CITY OF PORT LAVACA

SUBJECT: Animal Shelter renovations

Subject: B&R RFP-353-008 – Revision 1
Project Location: Port Lavaca Animal Control Center
Project Title: Renovations and Conversion of Kennel from Open Air to Enclosed Facility

Renovations and Additions to
Port Lavaca Animal Shelter
201 Stringham Port Lavaca, Texas 77979

SHEET NO.: A 4.0

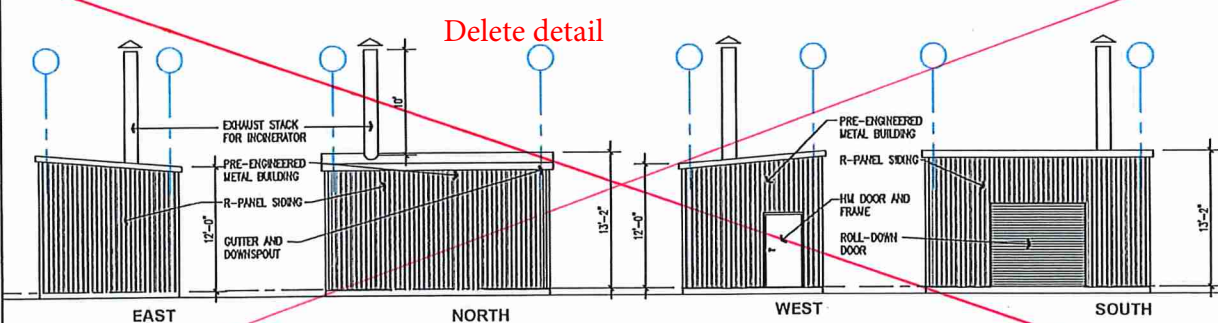
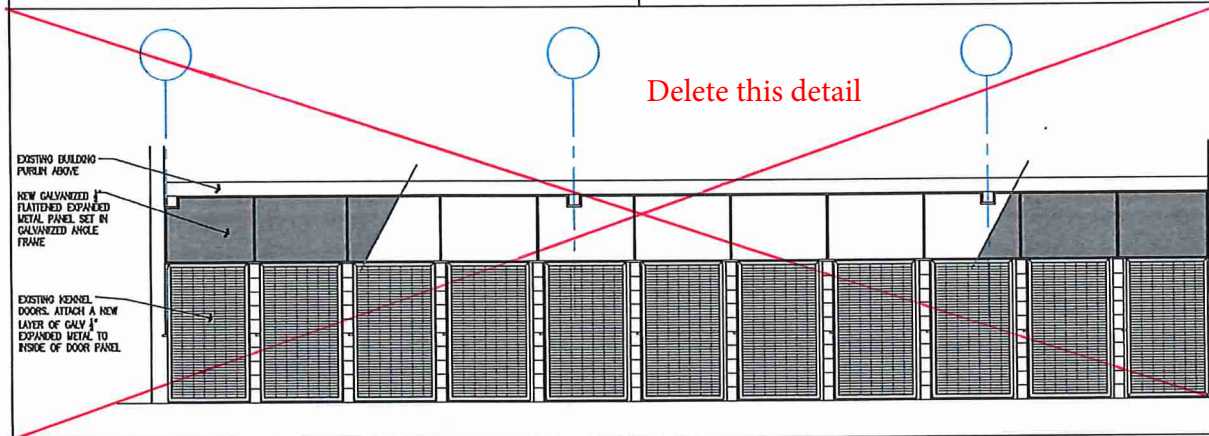
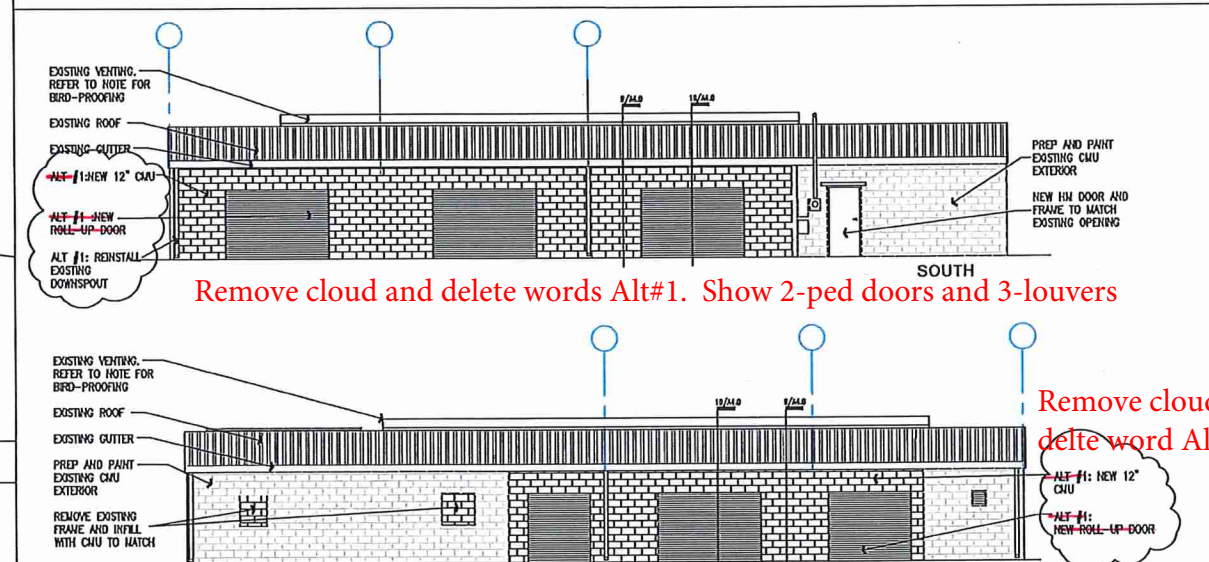
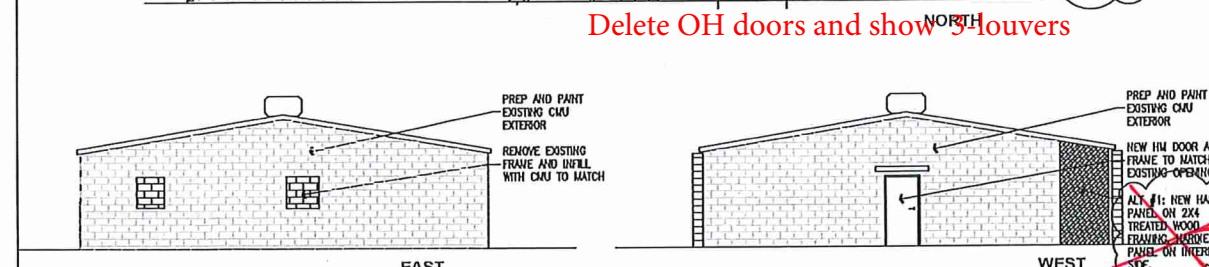
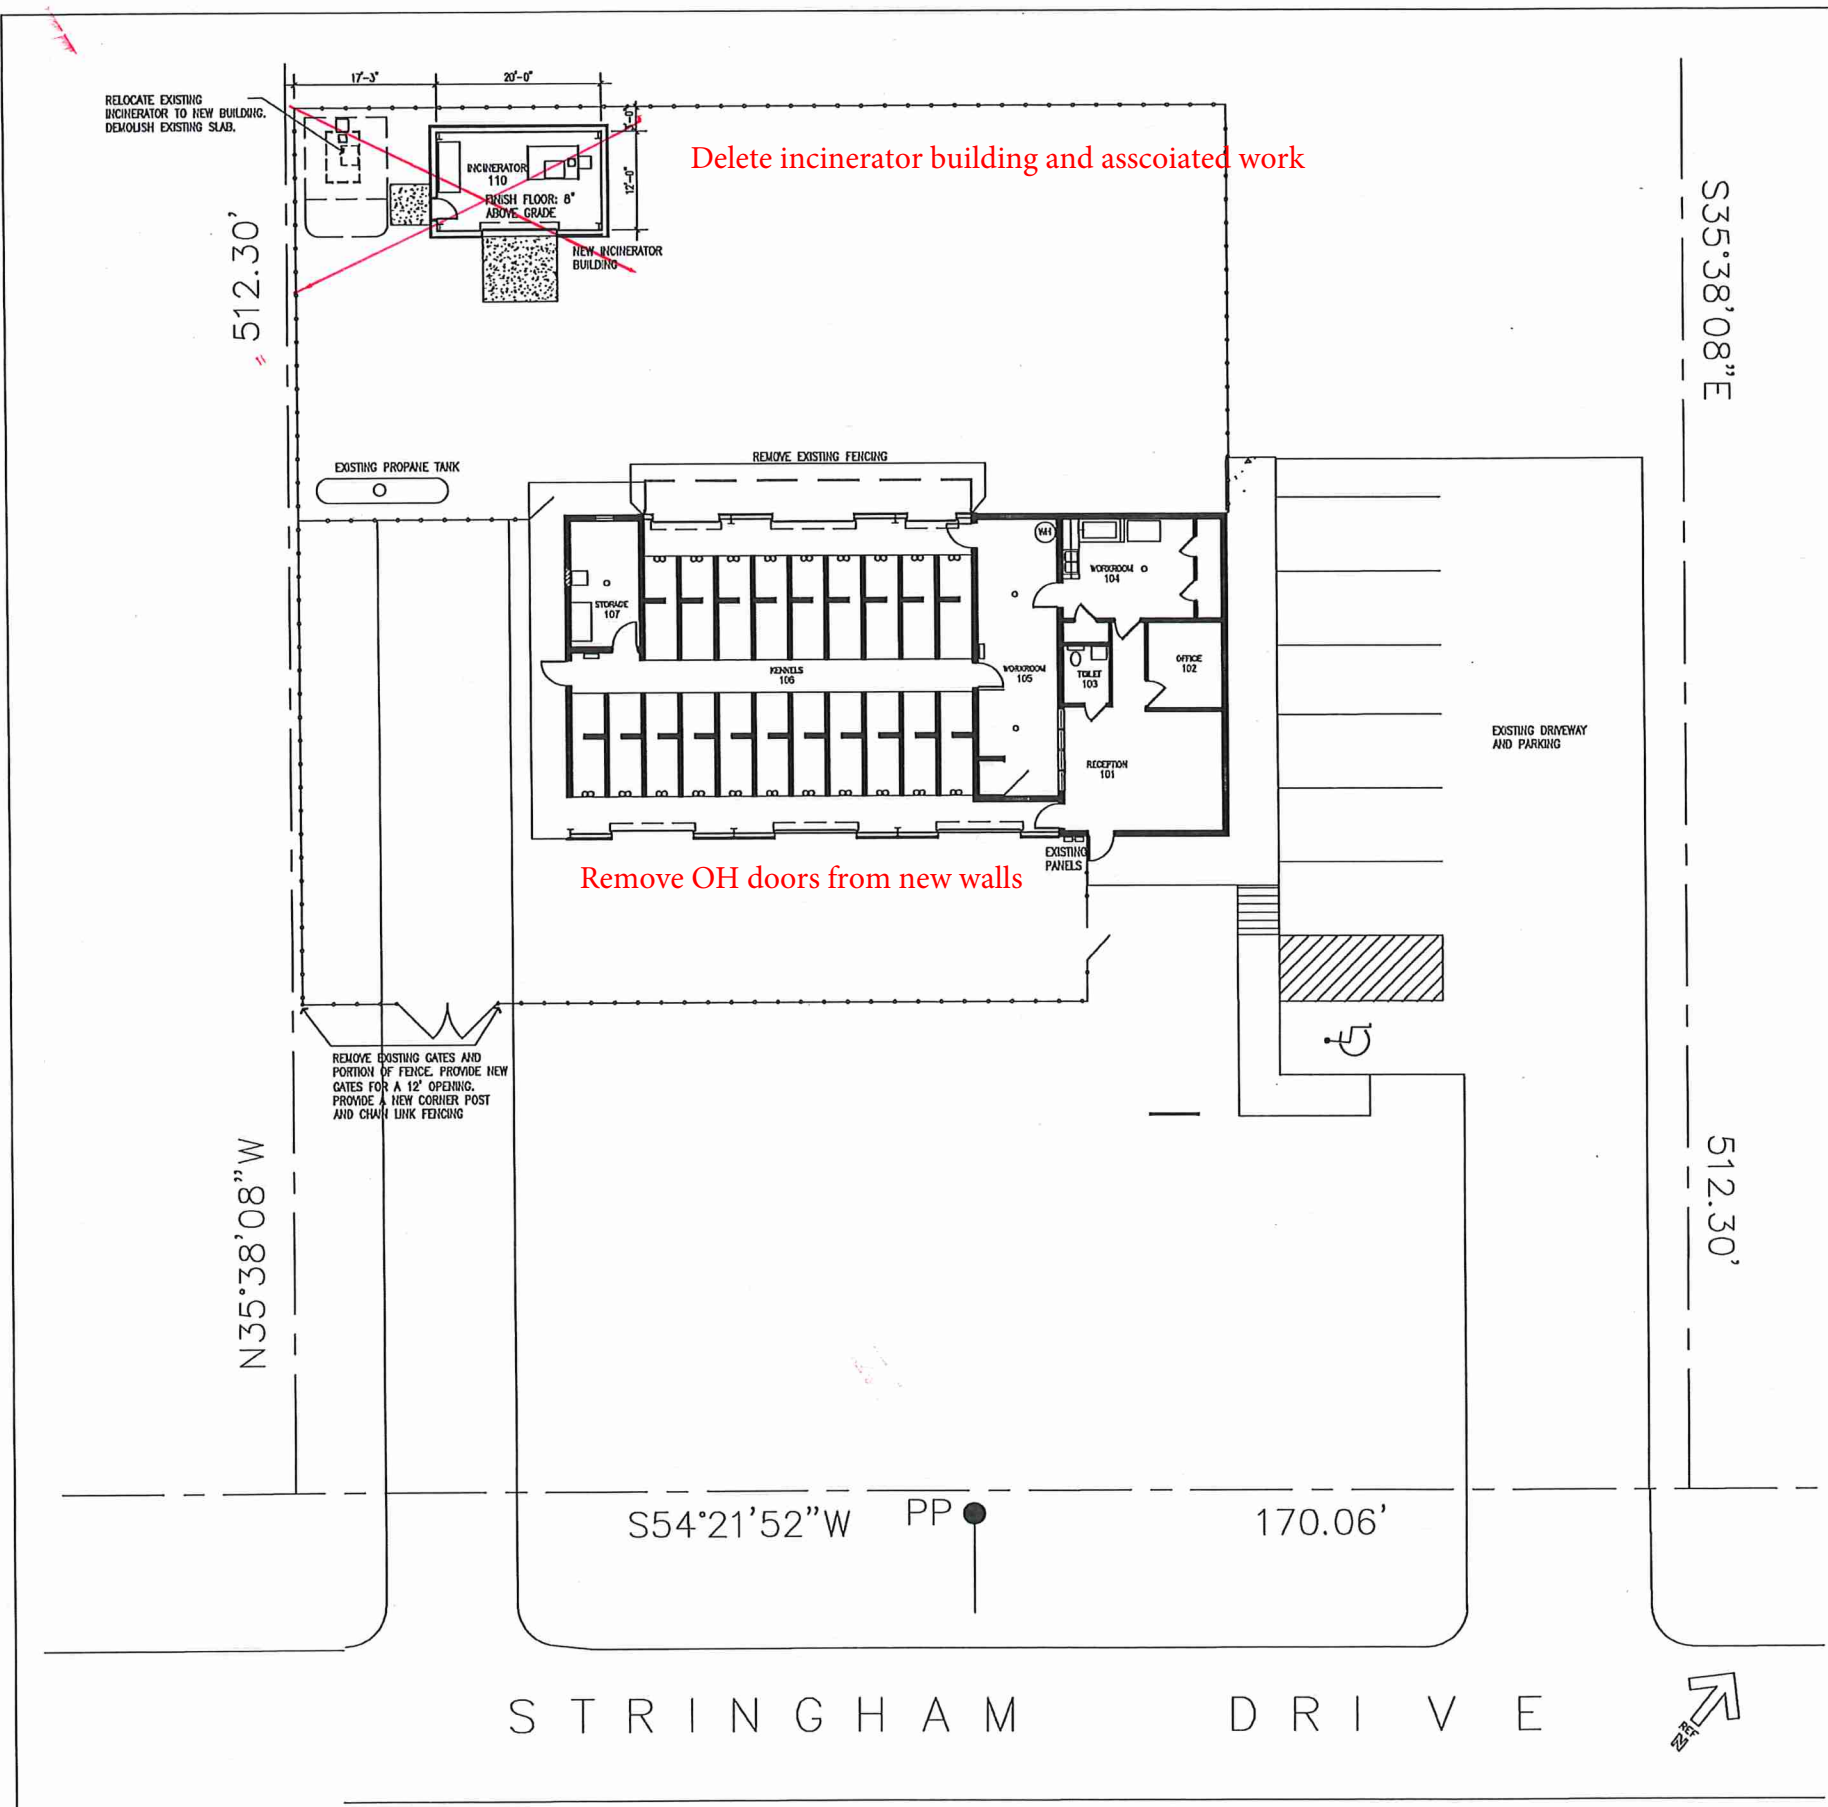
Remove cloud and delete words Alt#1. Show 2-ped doors and 3-louvers

Delete OH doors and show 3 louvers

Remove 2x4 framing and use 8" CMU

E1.0

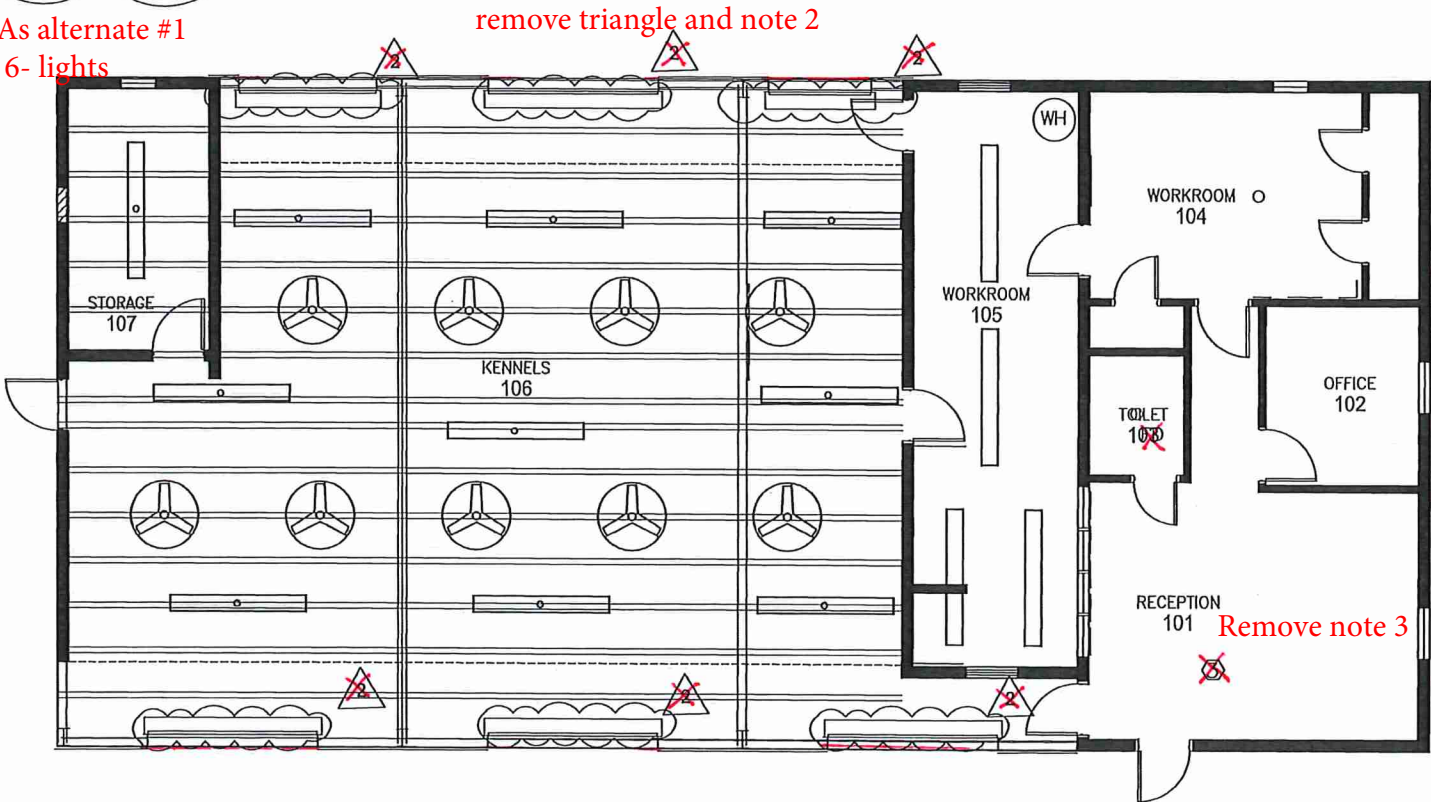
Delete all notes stricken through

E1.1

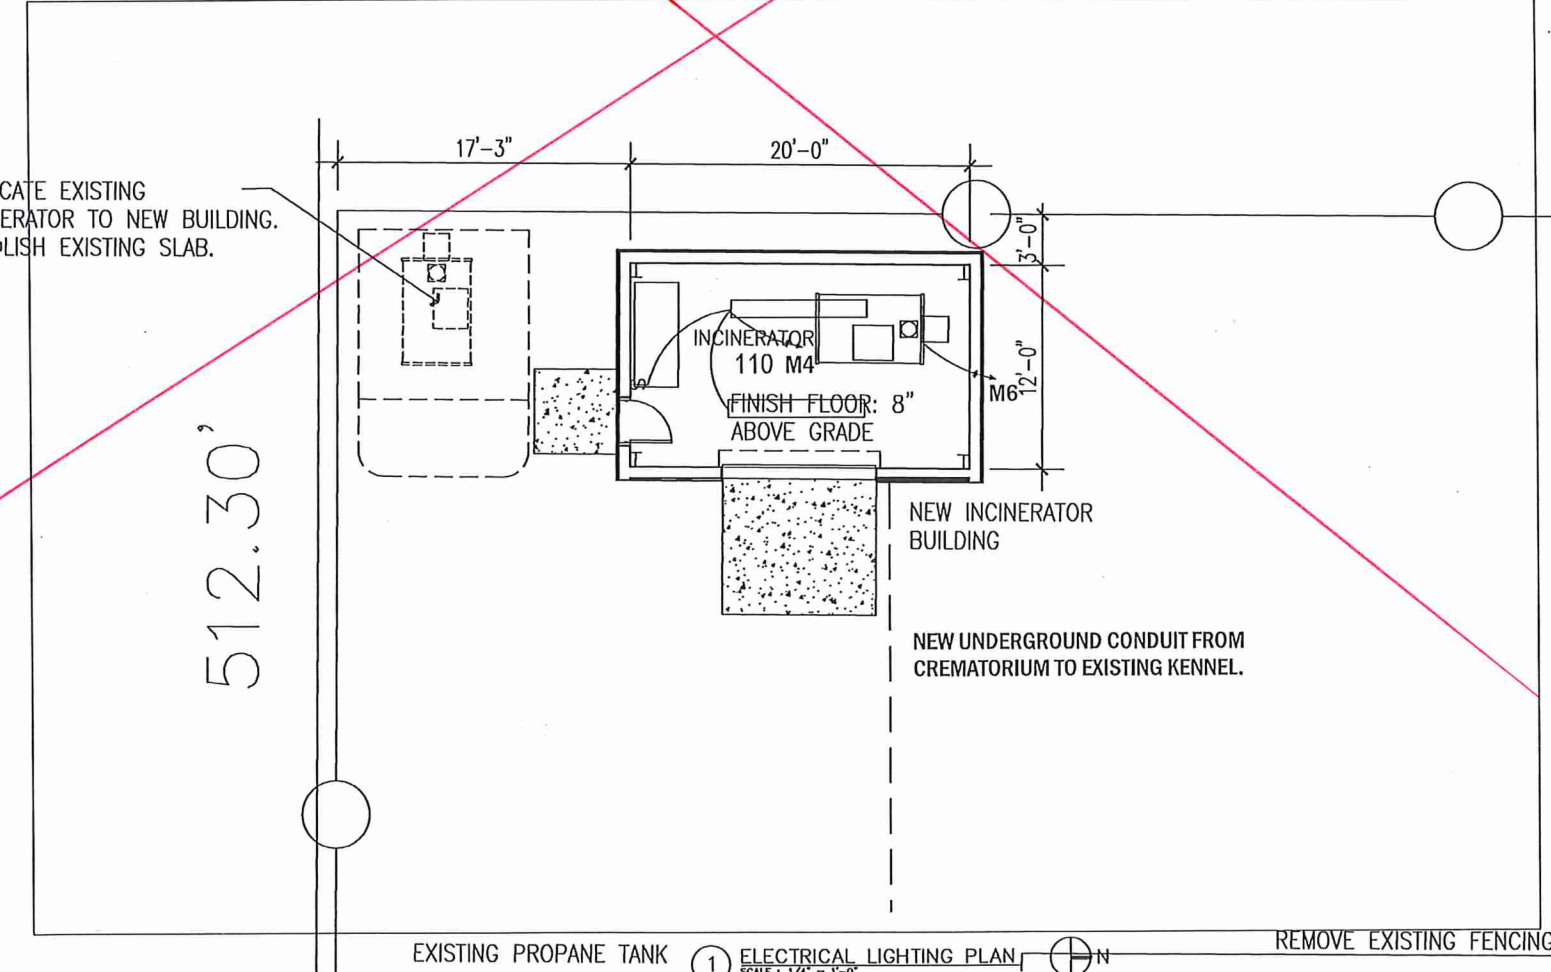
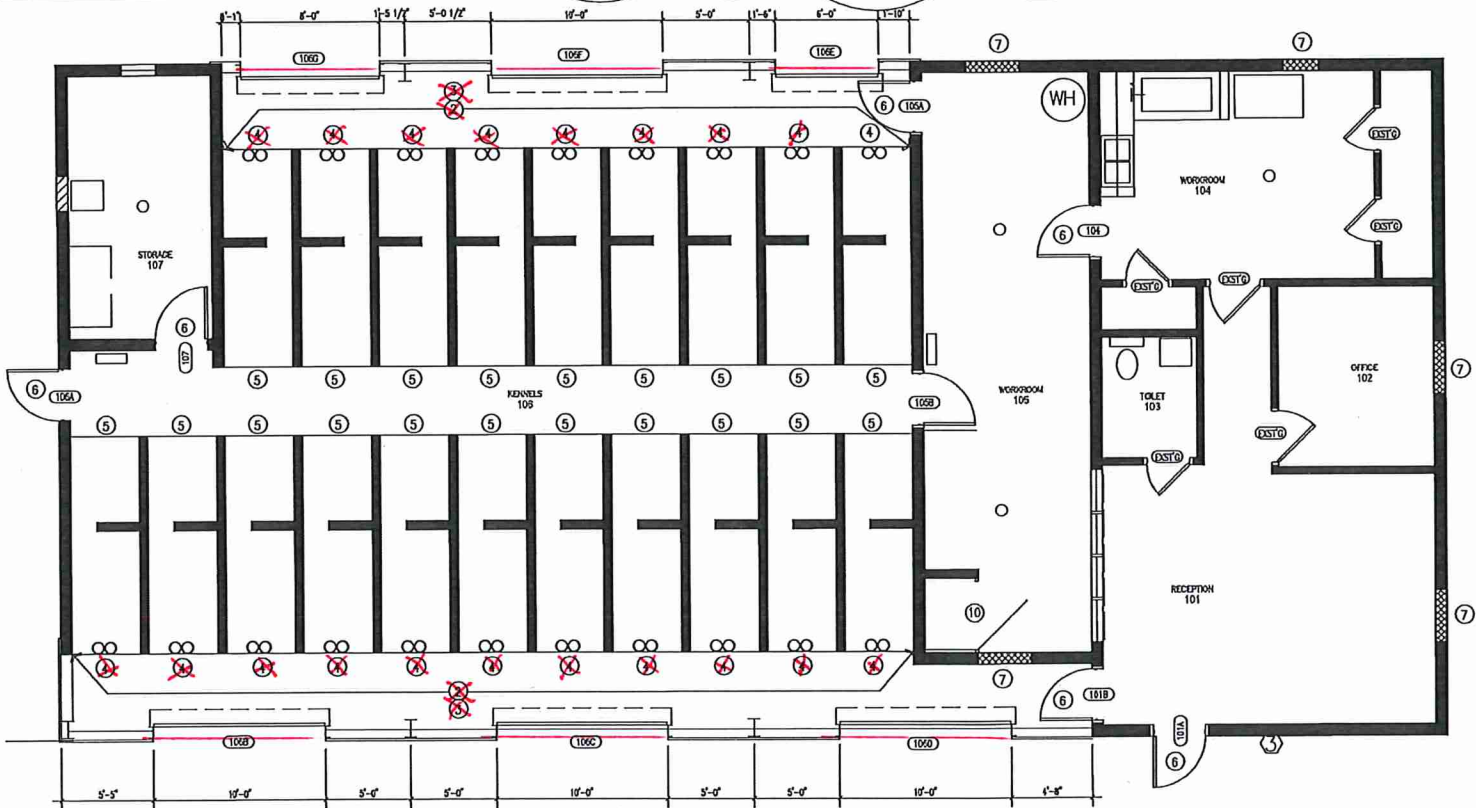
Remove all notes stricken through.
Remove circles and all notes 2, 3 & 4 in room 106
Remove OH doors from new walls
and show 2-ped doors.
Remove cloud

Delete 1 & 2 below
